SERVICE BULLETIN

SUBJECT: Weld nut and fillister head screw may spin freely and not tighten.

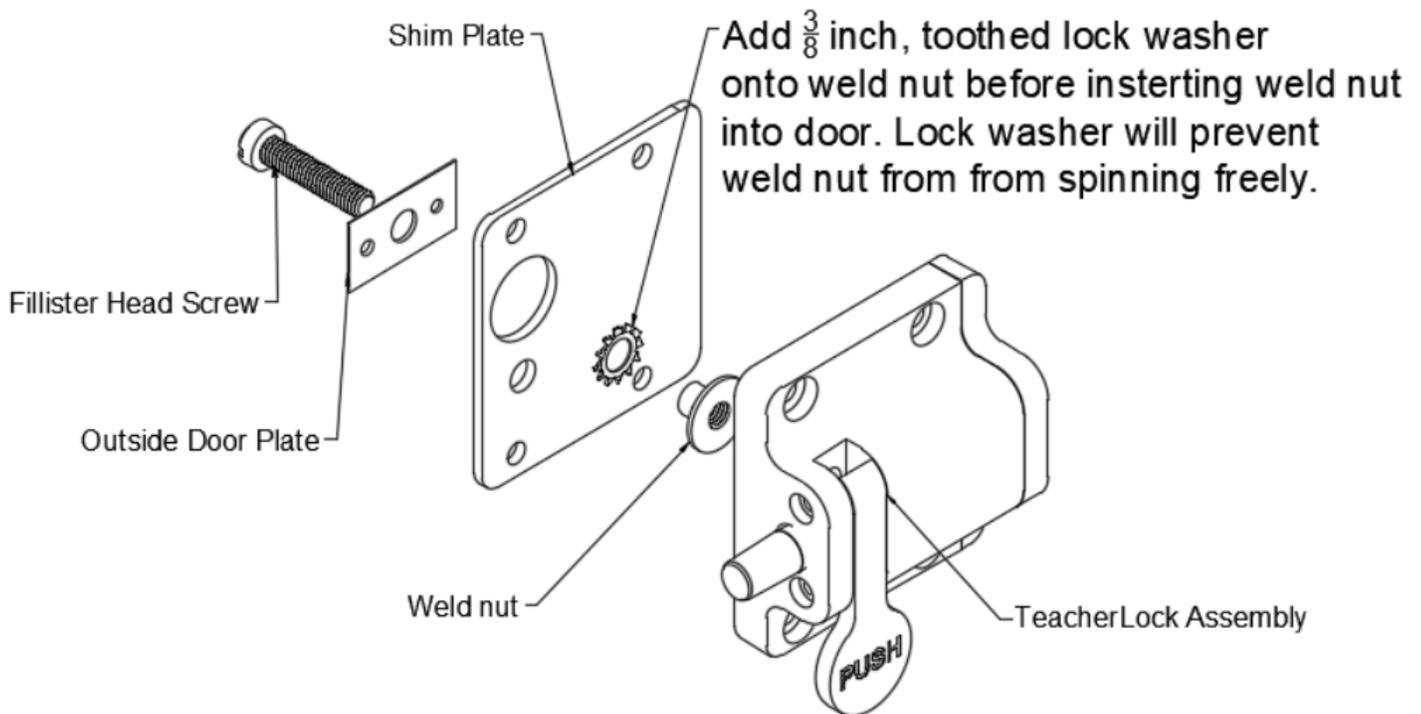
Weld nut may sometimes spin freely when fillister head screw is inserted or removed. This does not happen in all cases and is dependent on your installation. To prevent this from occurring in all situations we recommend the following.

Add a standard zinc coated steel 3/8" toothed lock washer onto the weld nut before assembling to the door. The weld nut will be held in place. Please note that Defcon Products will supply this lock washer free of charge.
